# **MYO FINAL MONITORING REPORT**

## **NESBIT SITE**

## Response to DMS Comments

### DMS Comments Received (Black Text) & Responses (Blue Text)

**CURRENT CONDITIONS PLAN VIEW**

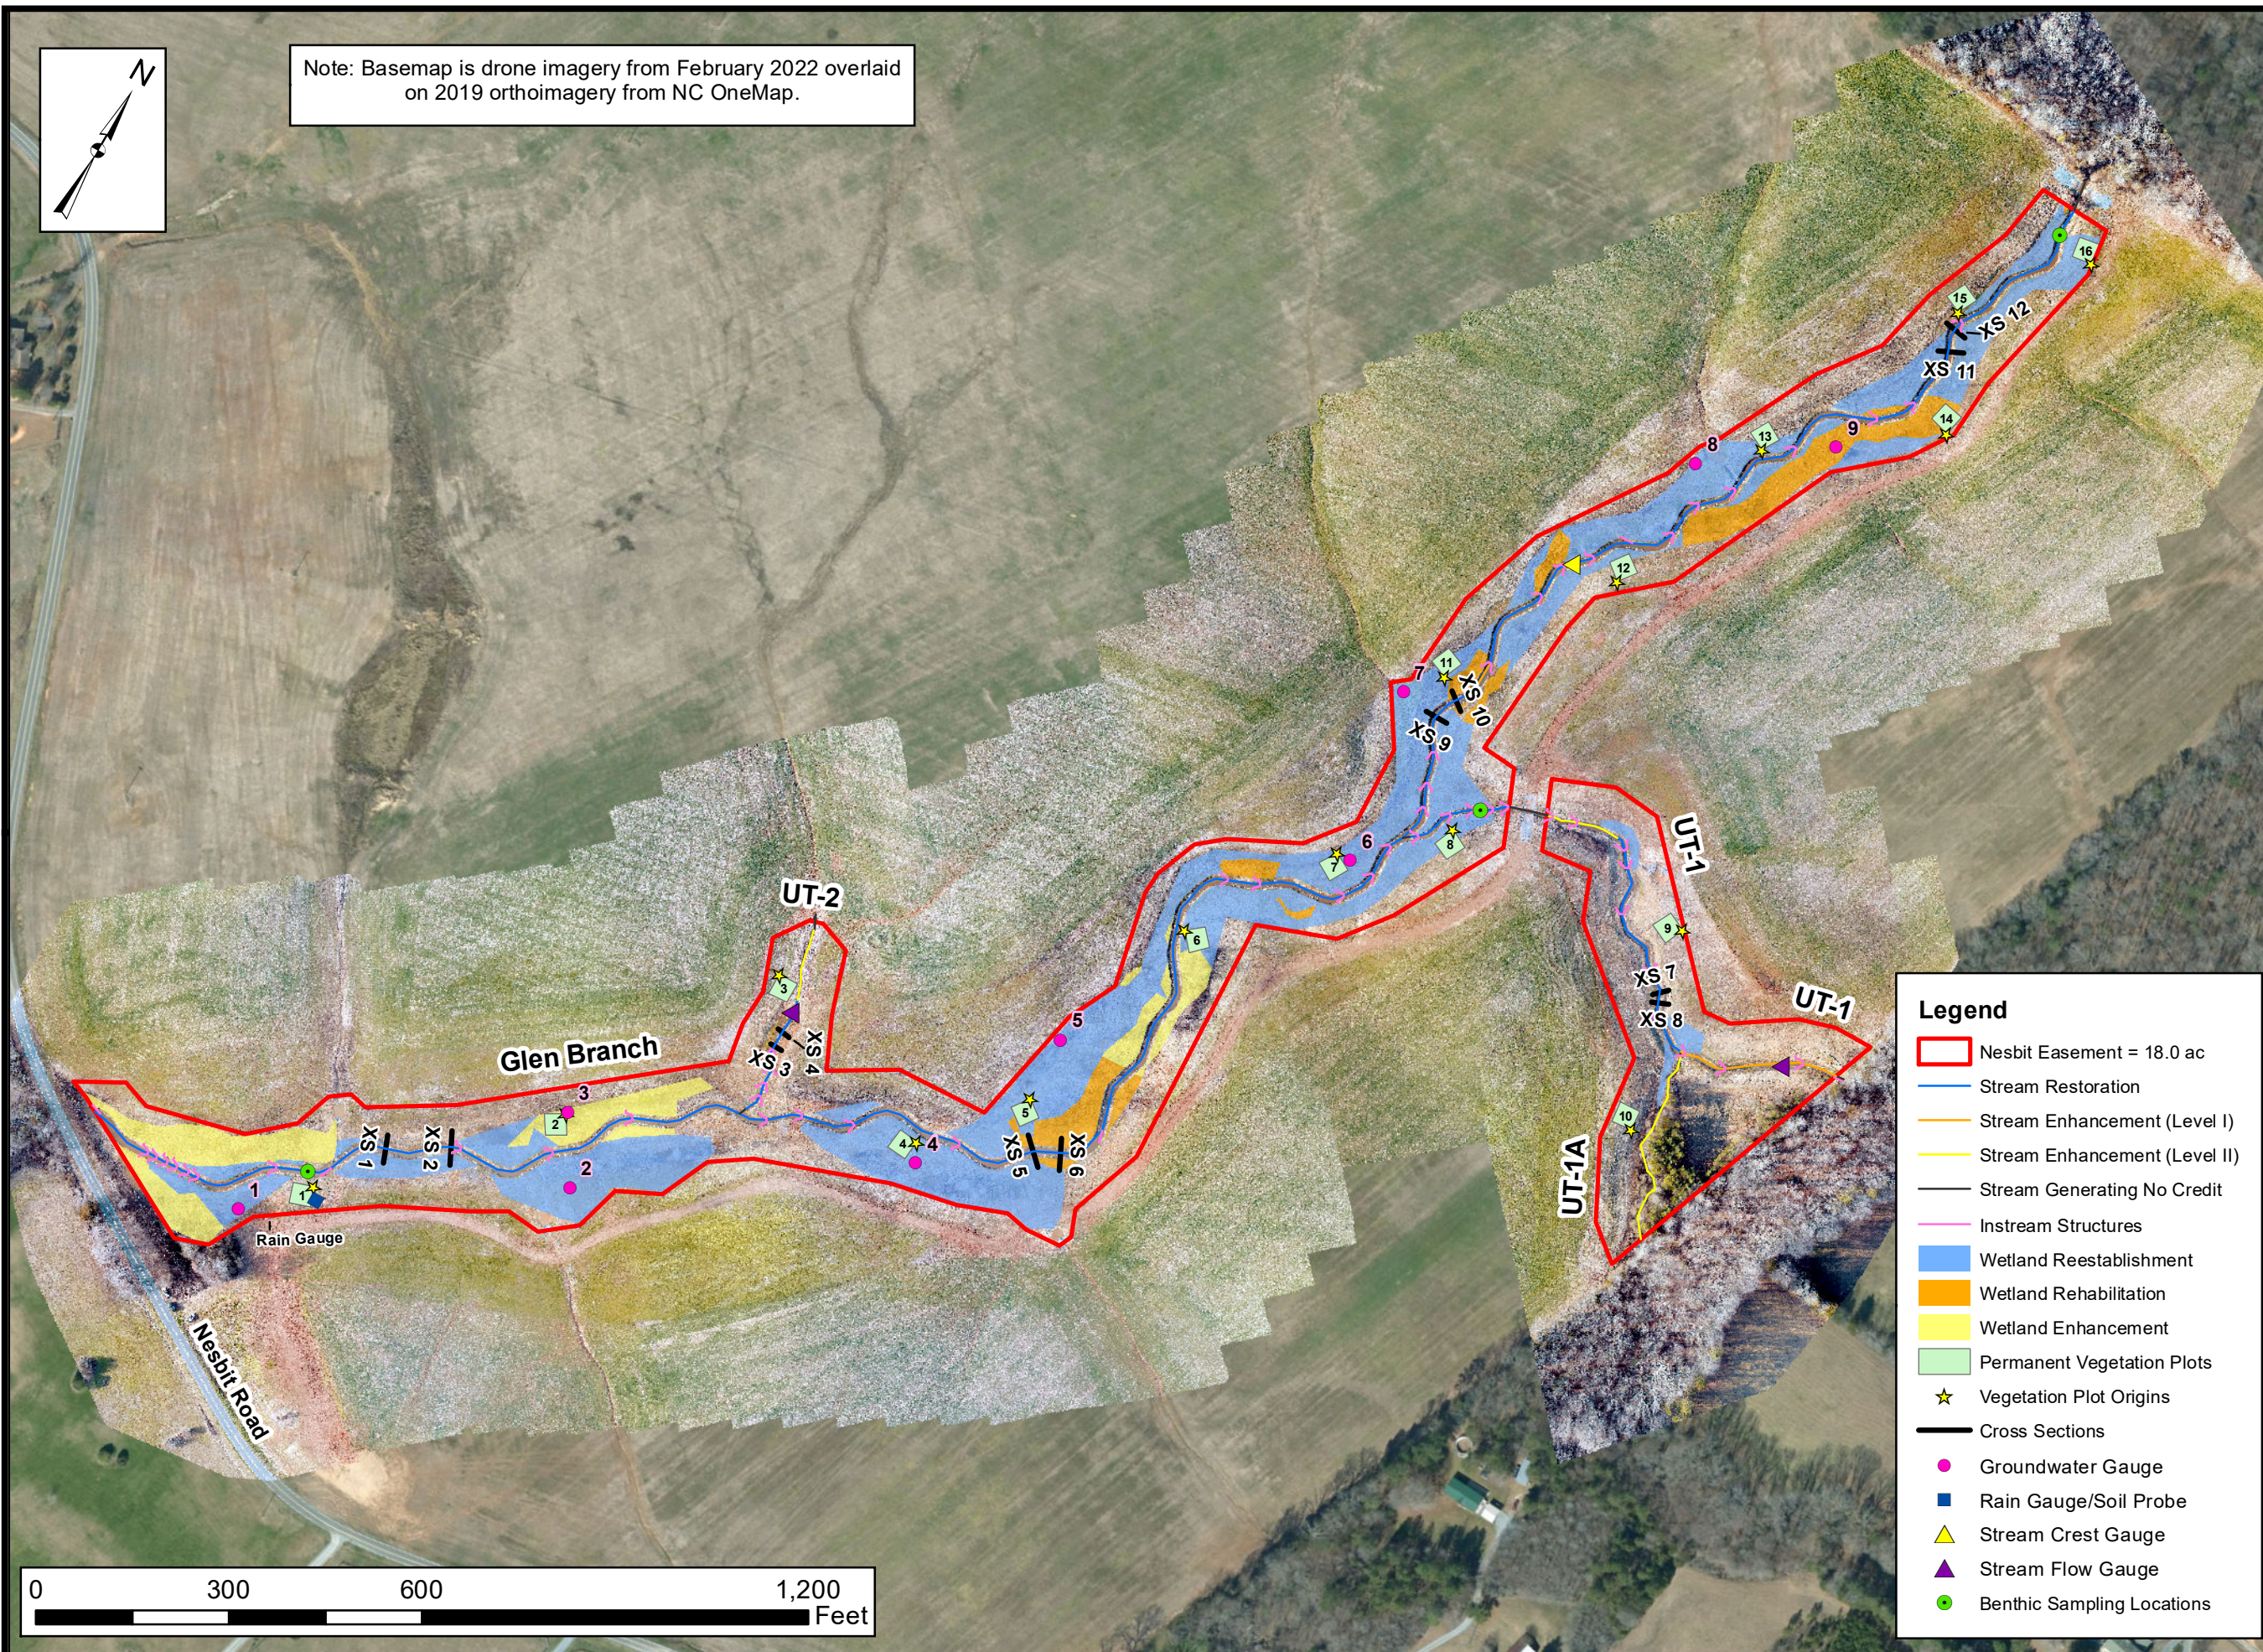
15. Please review the groundwater gauge labels, the labels on the CCPV included in the report differ from the labels in the digital submission (ex. Gauges 7, 8, 11, and 12).  
[Response: There are only 9 groundwater gauges at this site labeled 1-9. The labels in the digital submittal match the labels on the CCPV and soil boring logs. However, based on this comment, all shapefile labels were checked, and it was discovered that the cross-section labels do not match the CCPV. This has been corrected.](#)

SHEET NO.  
**AB-03**

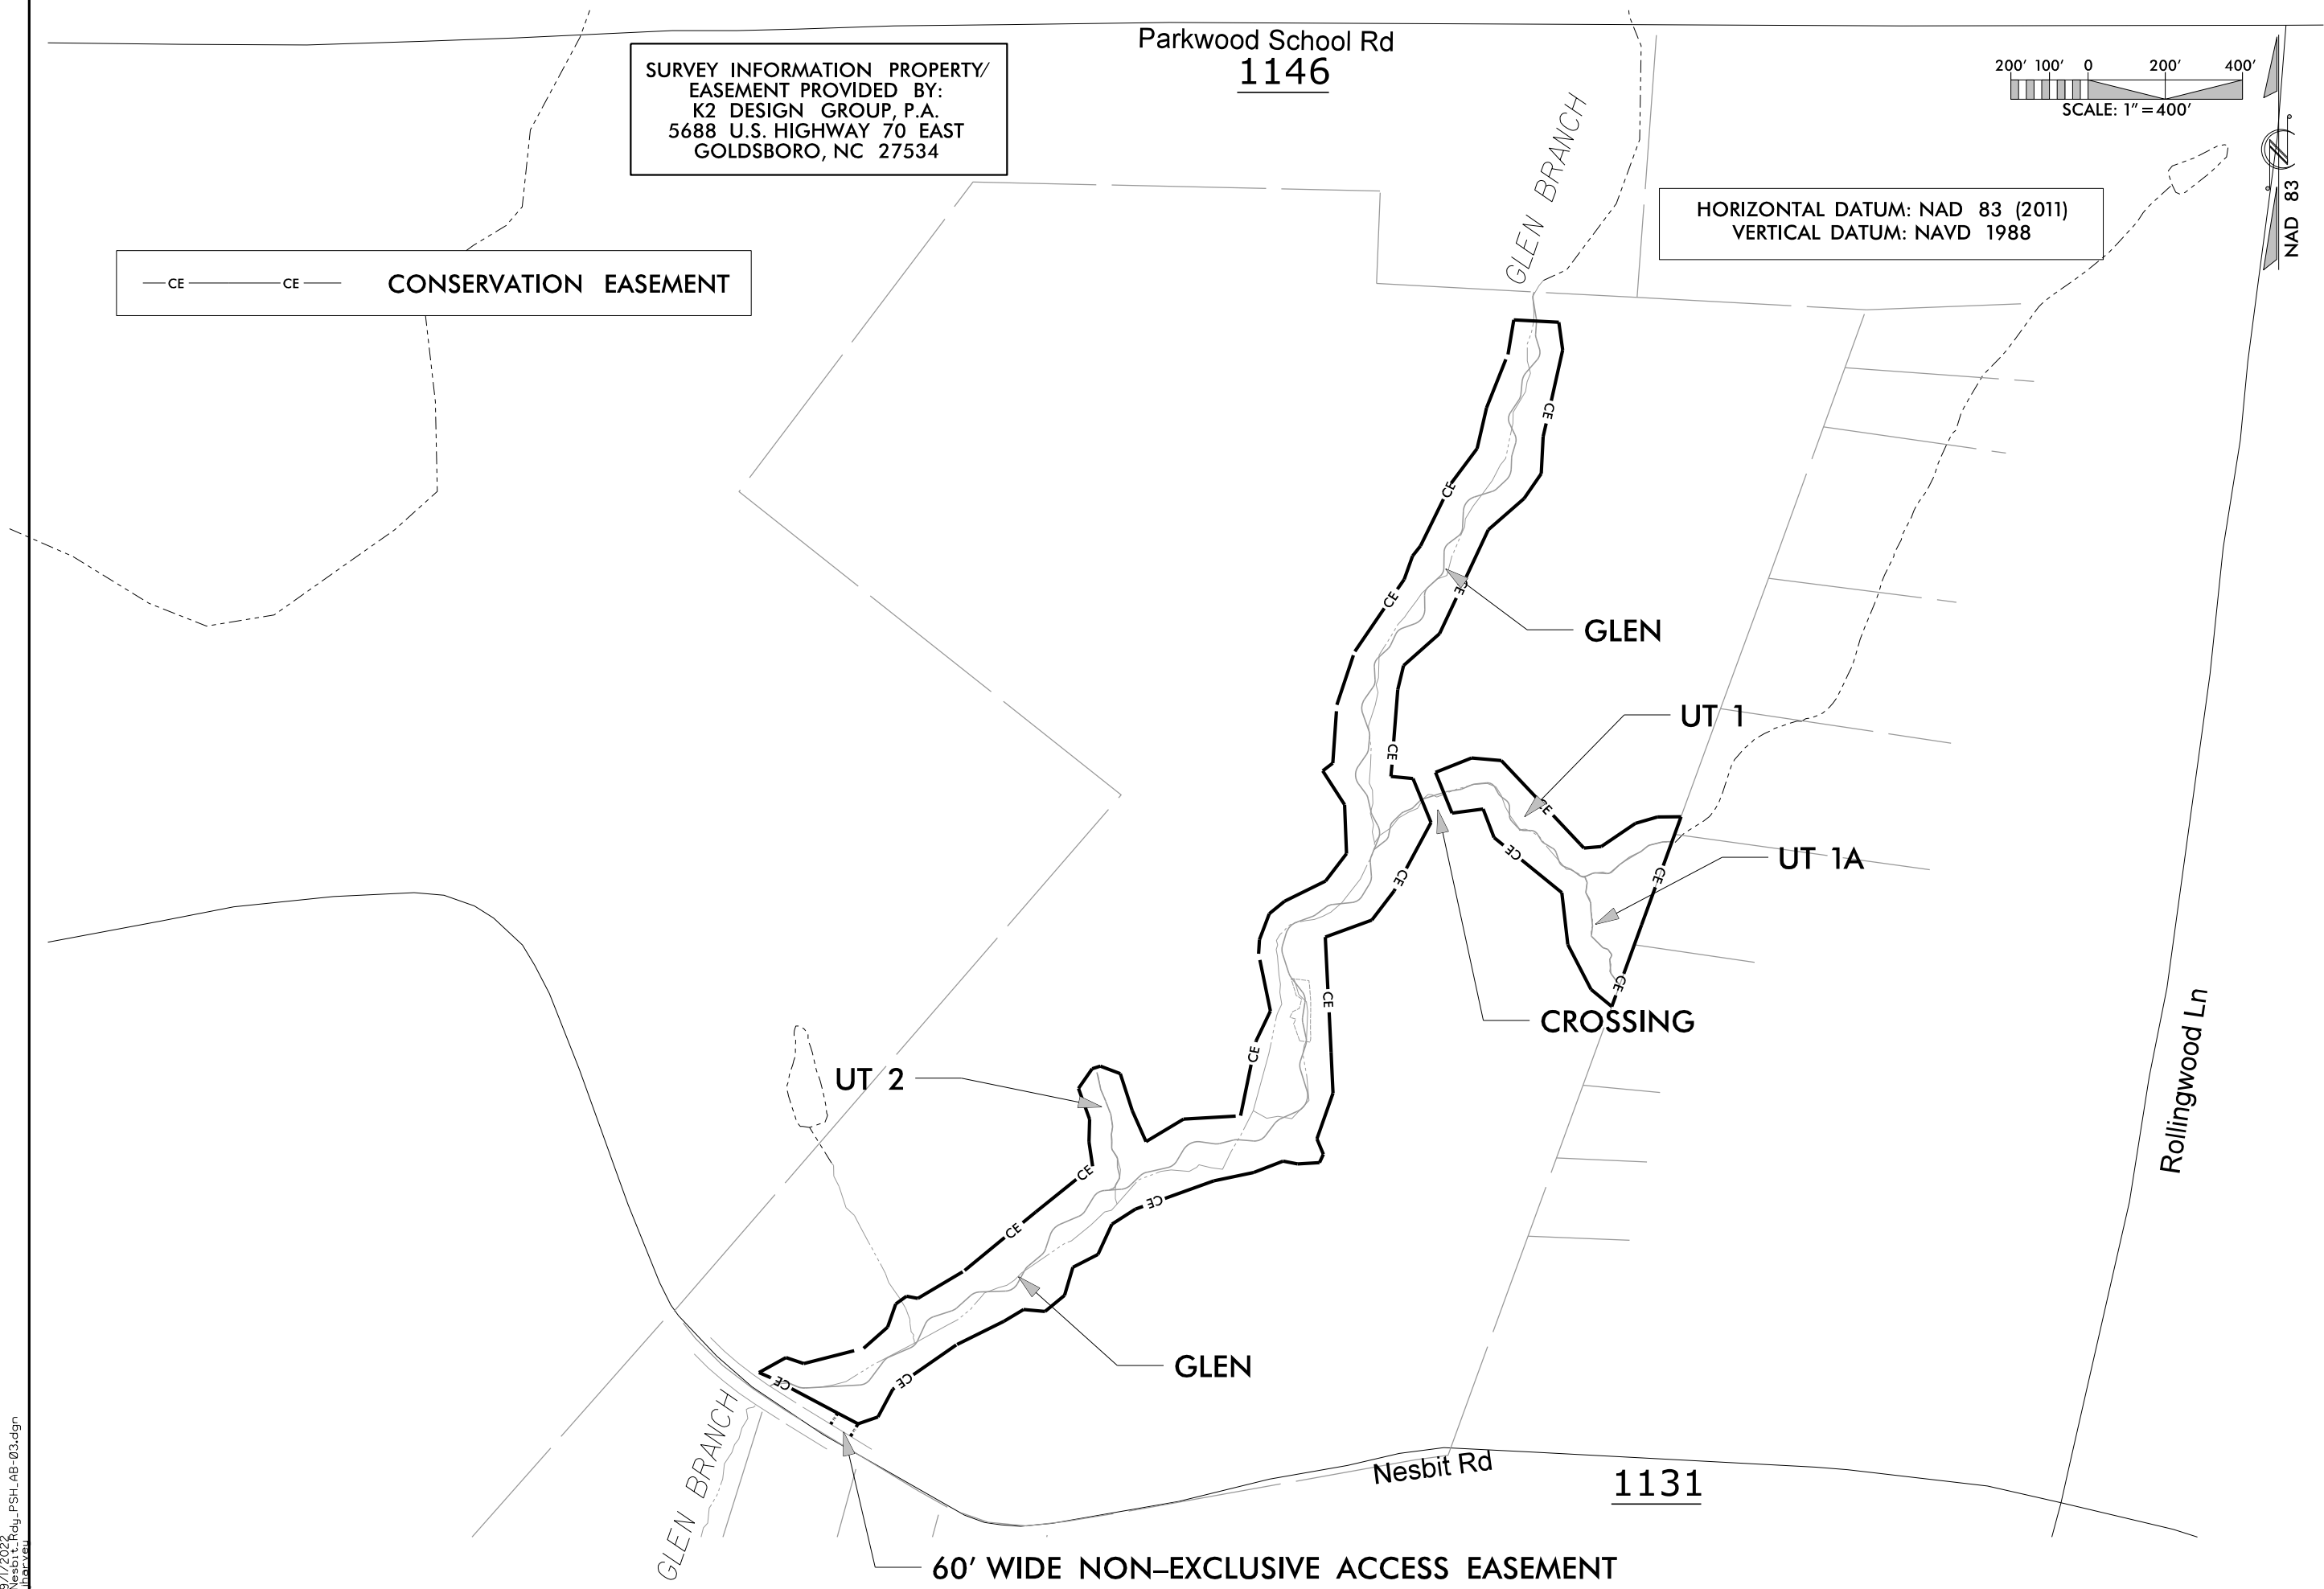
8. Sheet AB-03: Add callout for crossing.  
Response: UT1 crossing, and 60' access easement notes added
9. Sheet AB-04I and AB-041H: Add 60' Easement for Ingress/Egress/Regress.
